BUCKEYE PARTNERS, L.P.

REFERENCE: CPF No. 1-2009-5002

Buckeye Partners, L.P. (Buckeye) received your "Notice of Probable Violation, Notice of Probable Civil Penalty and Notice of Proposed Compliance Order" (NOPV/PCO) dated June 26, 2009 concerning the PHMSA Integrated Inspection that was held in 2008 at Buckeye. Buckeye first responded to that letter on July 15, 2009, requesting a 60 day extension to develop its response.

ITEM 1-1

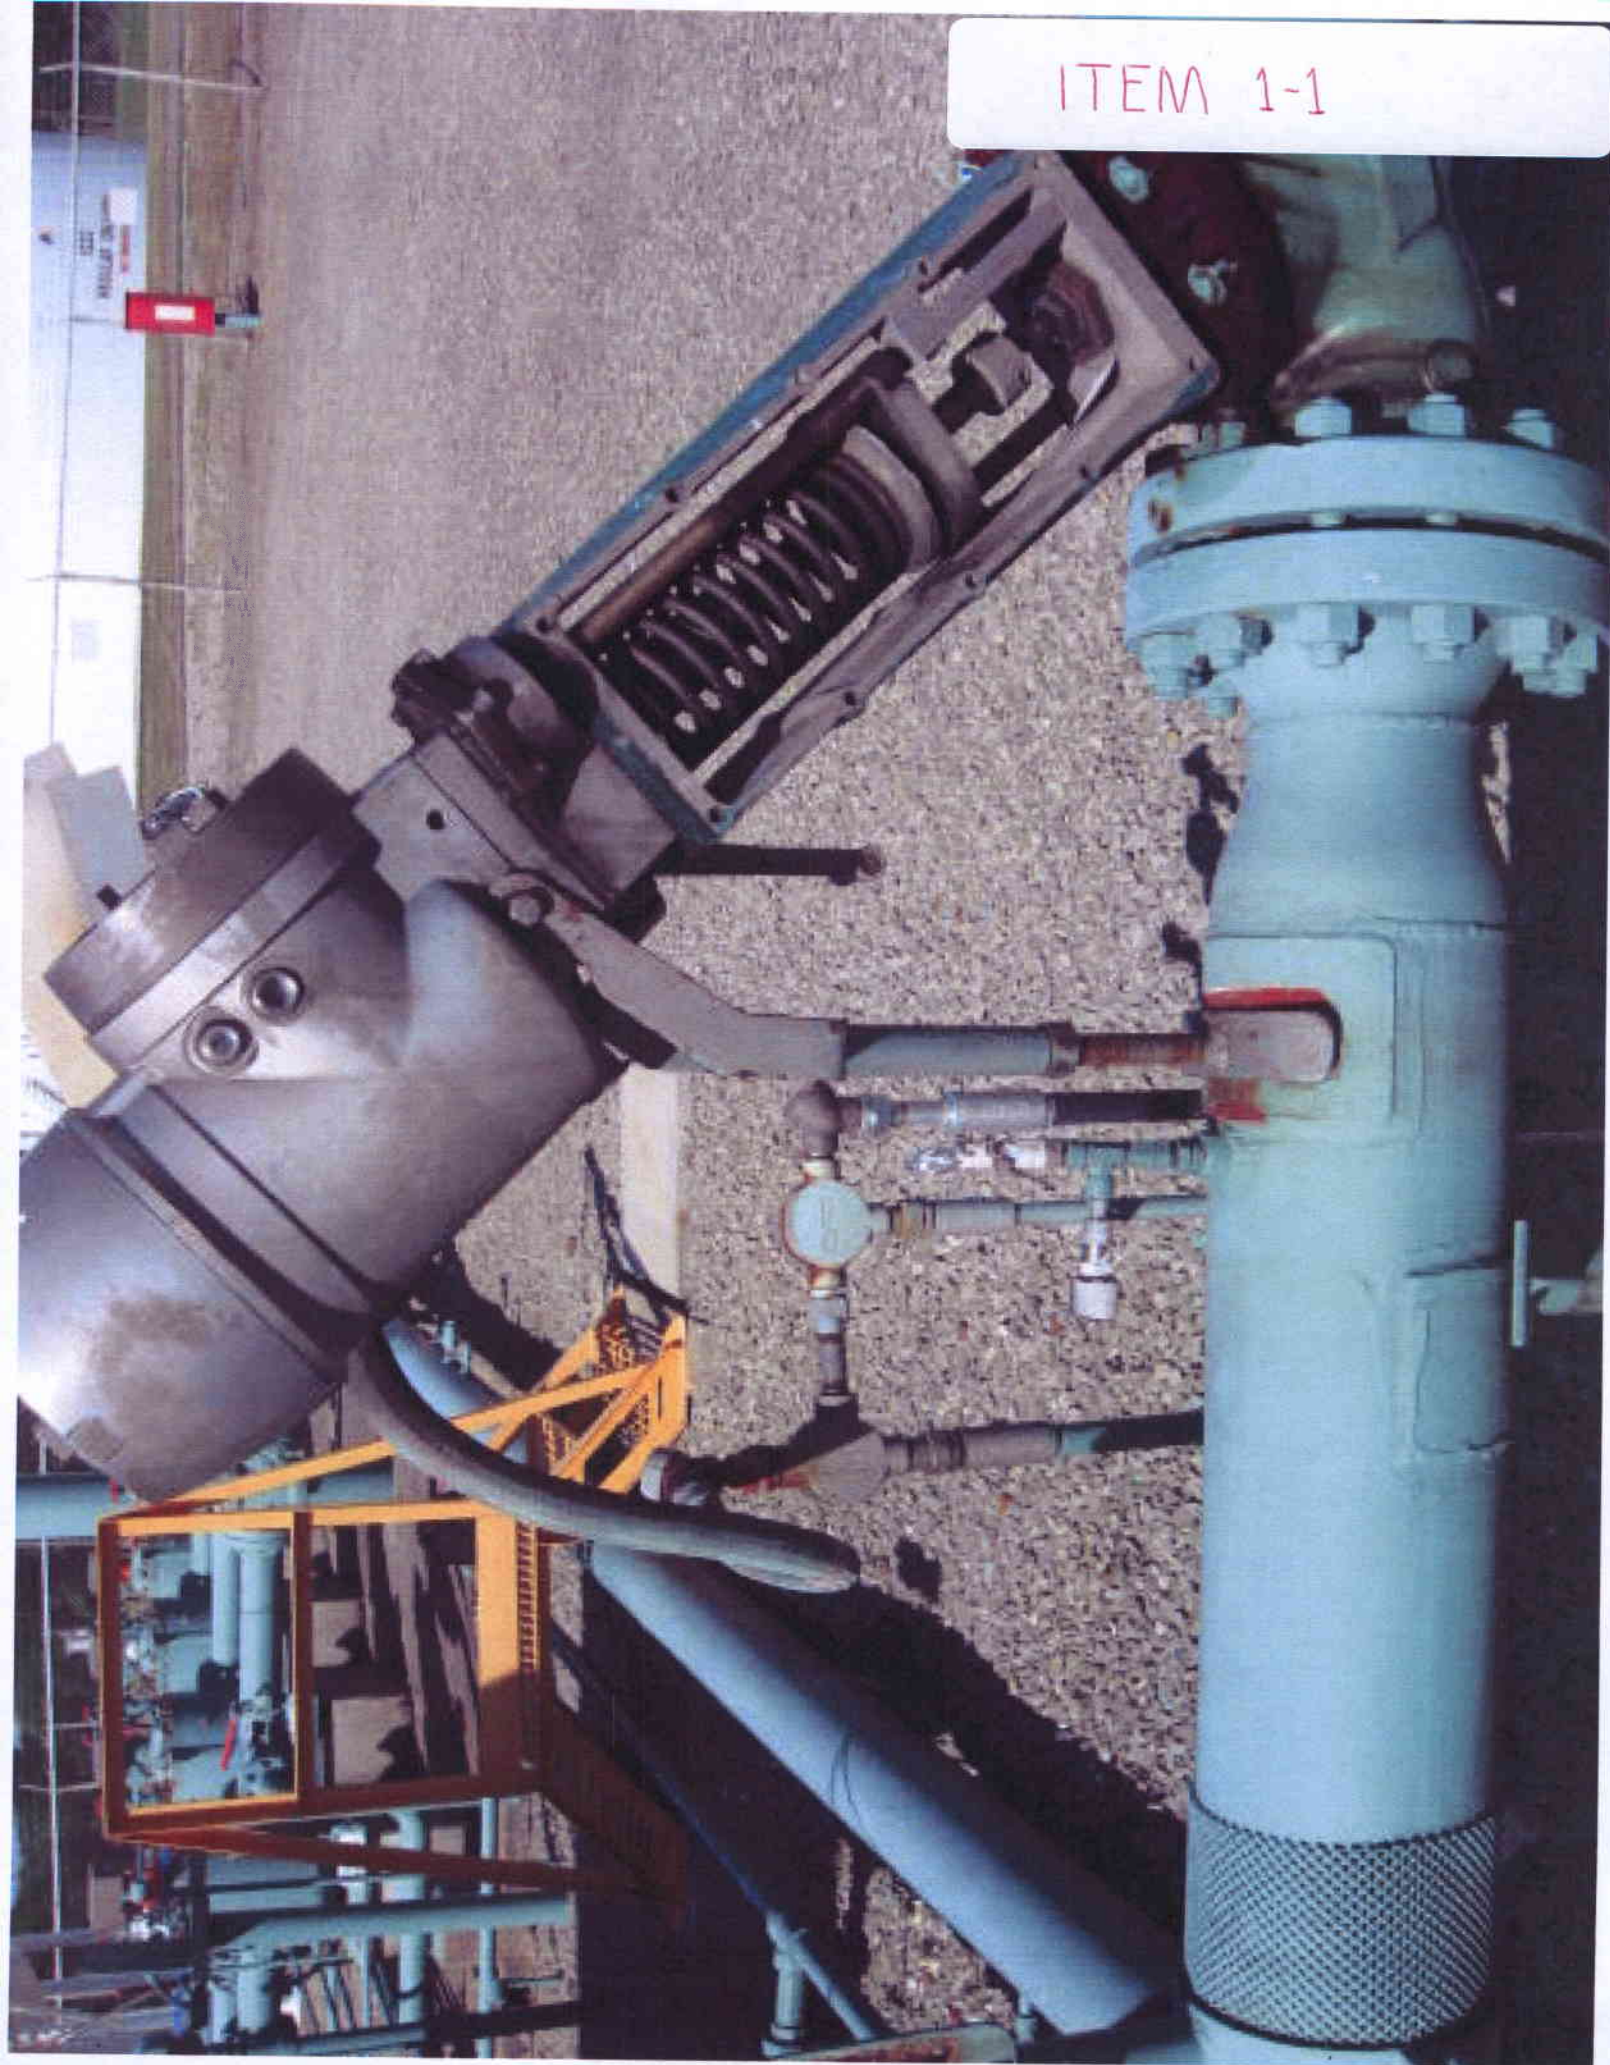
The inspection team discovered that 1) a block of wood was being used as support for a control valve in the Greensburg Station; 2) a support device at a tank farm in Toledo, Ohio was installed on the 16-inch manifold where pipe modifications had been made, but no associated concrete foundation was present under the pipe support; 3) at the Malvern Station, the pipeline was found to be in contact with a cutoff section of pipe near a line tank; and 4) at the Greensburg Station, the pipeline was found to be in non-intentional contact with a concrete block at the pig receiver. Buckeye failed to correct these adverse conditions within a reasonable time, as required by the regulation

Buckeye's Response: Proper supports have been installed at Greensburg Station and Toledo Tank Farm. The pipe that was in contact with a cutoff piece of pipe at Malvern Station has been corrected. At Greensburg Station, the concrete block was cut back to provide several inches of clearance. When the block was cut away, it was determined that the concrete was not in direct contact with the pipe. All of the above items have been addressed and corrected (photos enclosed).
